RE: Townhomes for Greg Lobbereg
Grading and Drainage Plan
Engineer's Stamp Date 2-6-2017 (File: H22D026)

RE: 2400 Marie Park Townhomes (H22 / D1026)

Thank you for your review comments of January 20, which have been addressed as follows:

DRAWING TITLE:
GRADING & DRAINAGE PLAN

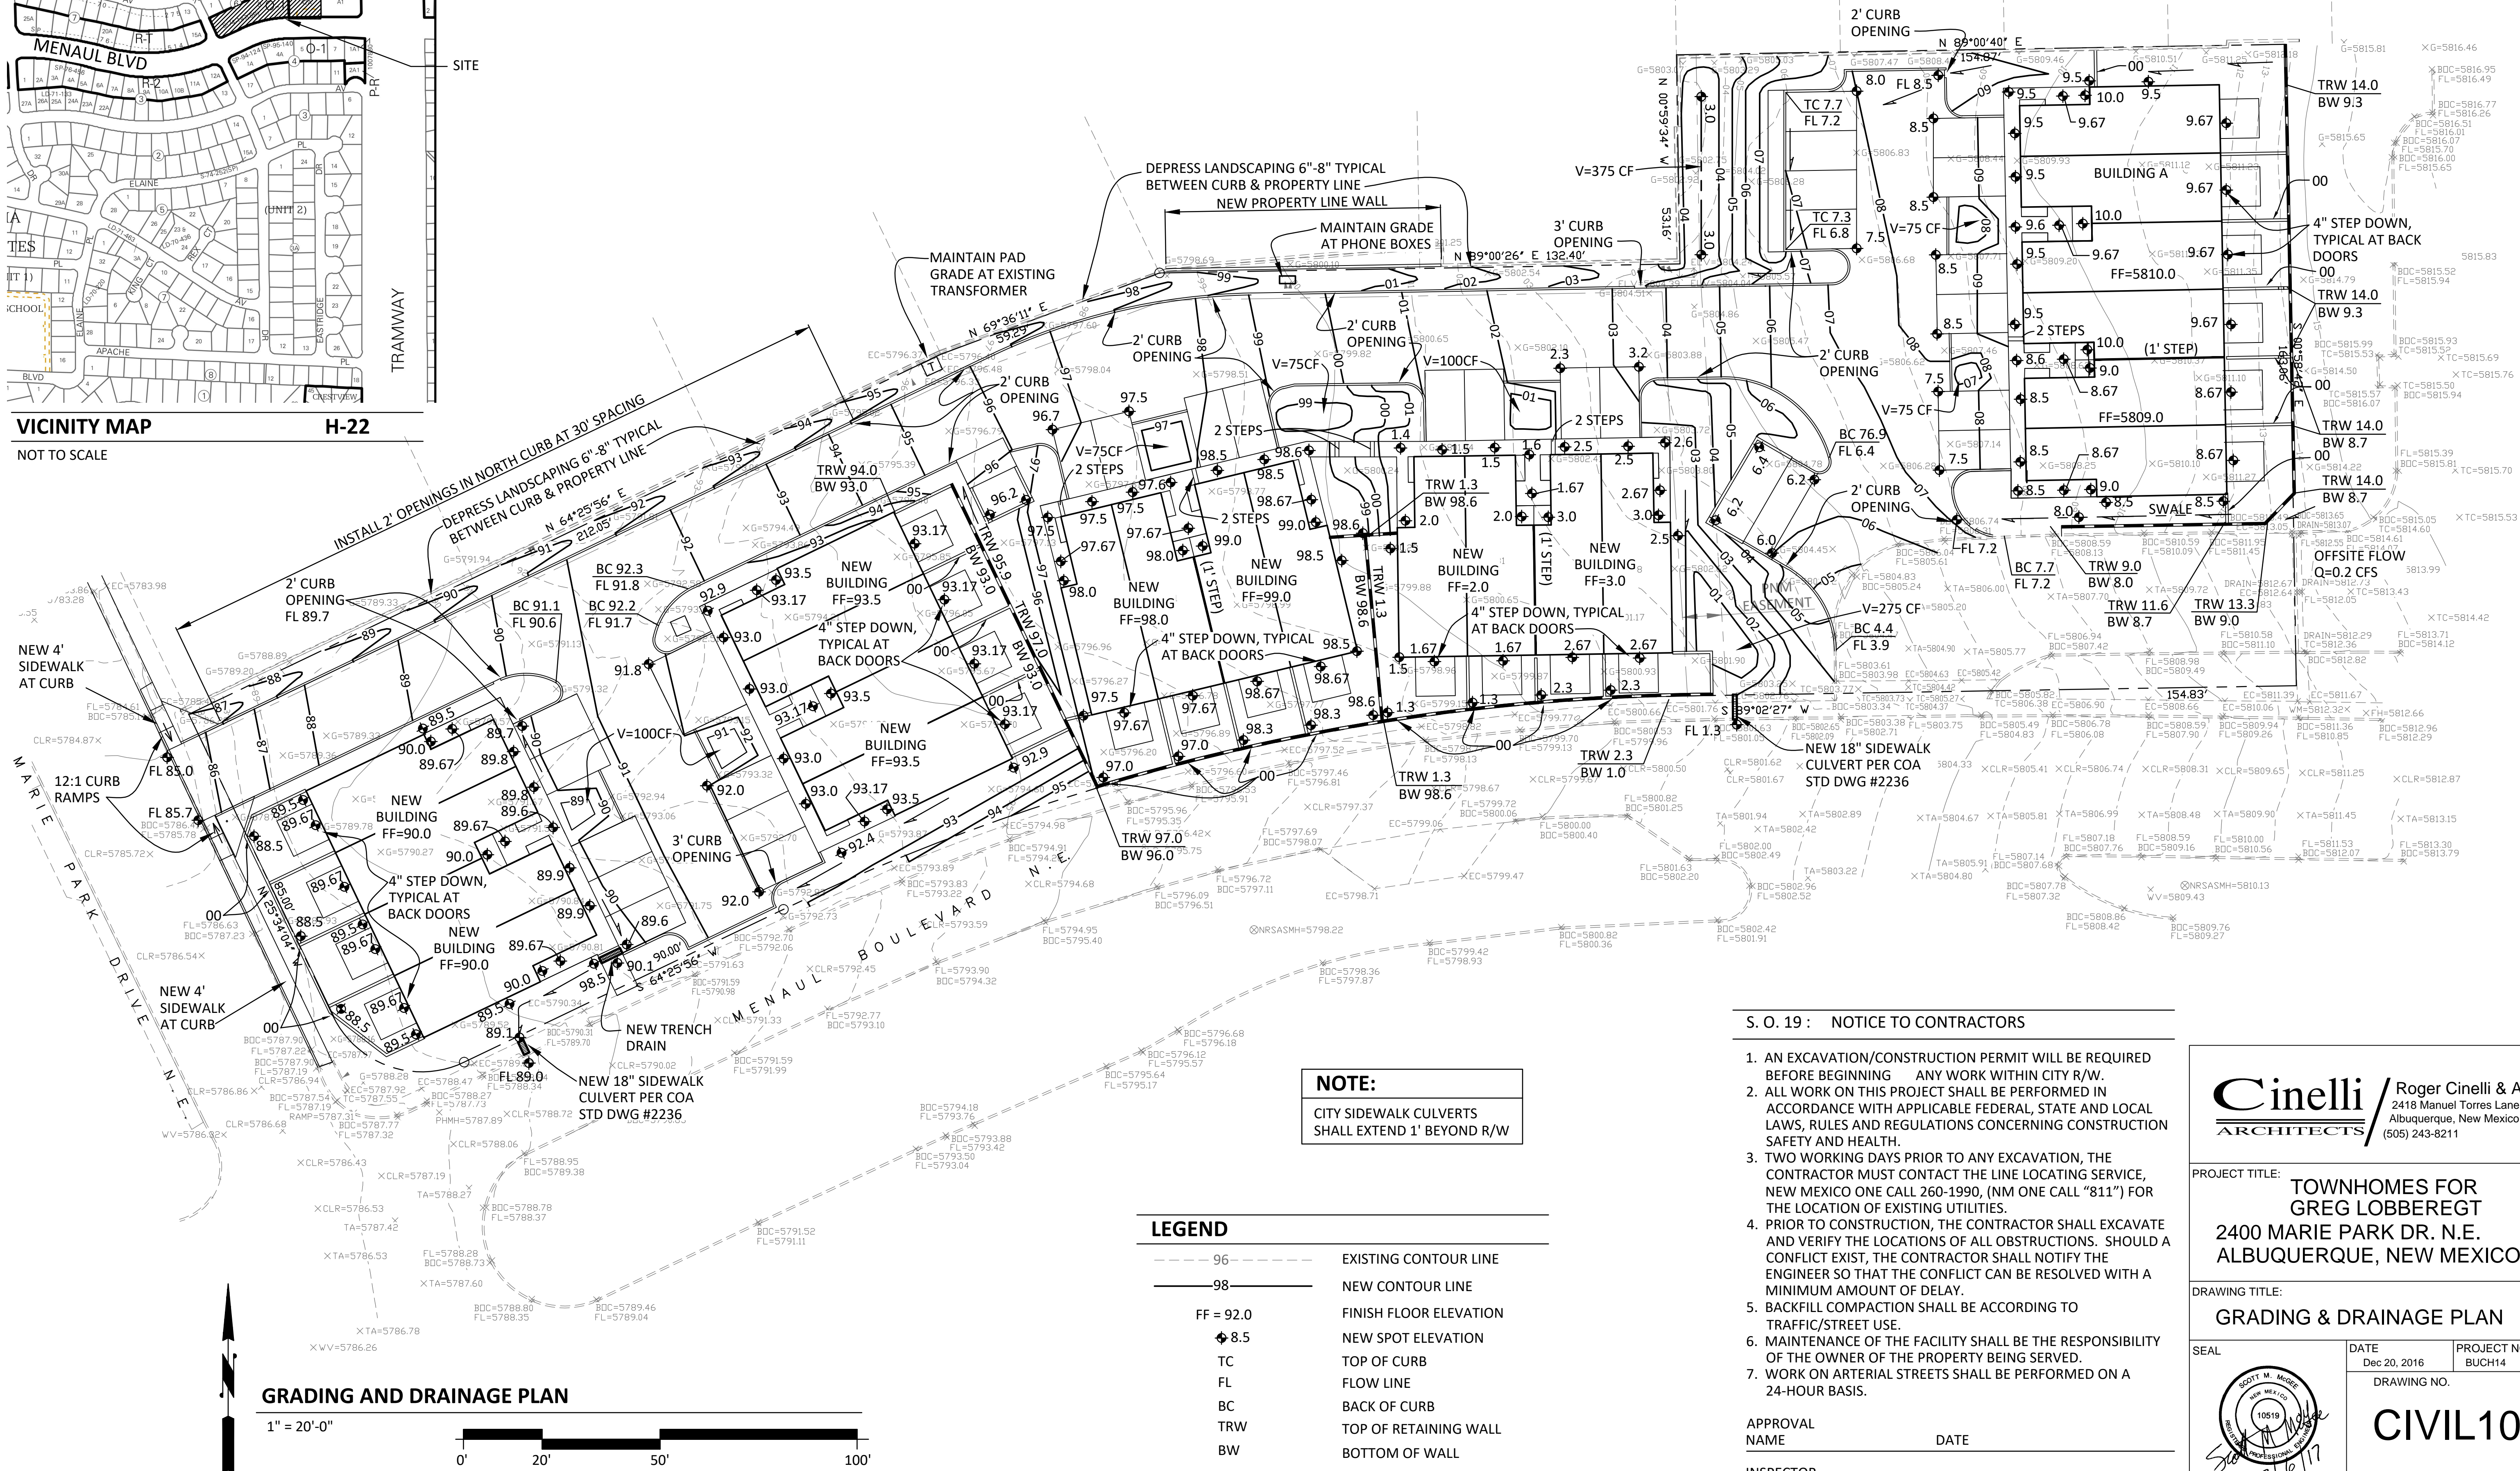
- 1-2. Vicinity Map and Offsite flow narrative have been added.
3. Typical unit and backyard detail has been included.
4. The 1st flush volume calculations have been revised.
- 5-6. Additional curb cuts have been noted on the plan.
7. Landscape strip north of access drive has been noted and shown as depressed.
8. The ESC plan is being prepared by others.
9. Backyards of units that back up to public streets are now shown draining to the street.
10. A note has been added requiring sidewalk culverts to be extended 1' beyond R/W line.

NOTE:
CITY SIDEWALK CULVERTS
SHALL EXTEND 1' BEYOND R/W
